Informal document GRE-85-05  
85<sup>th</sup> GRE, 26-29 October 2021  
Agenda item 4 (d)

This presentation supports the draft proposal for the  
new 01 series of amendments to UN Regulation No. 150  
(GRE/2021/15)

# UPDATED DRAWINGS IN ANNEX 10

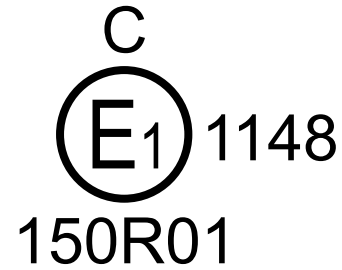
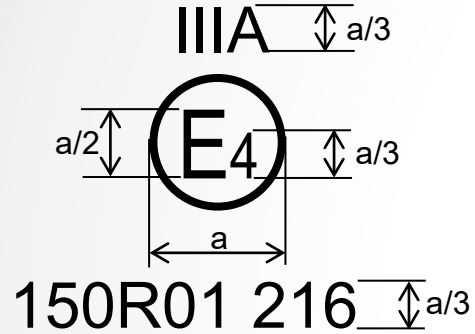
## Changes in the examples of the approval markings arrangement

- Space removed for class IIIA
- Size aligned
- “104R” removed
- “27R” replaced by WT
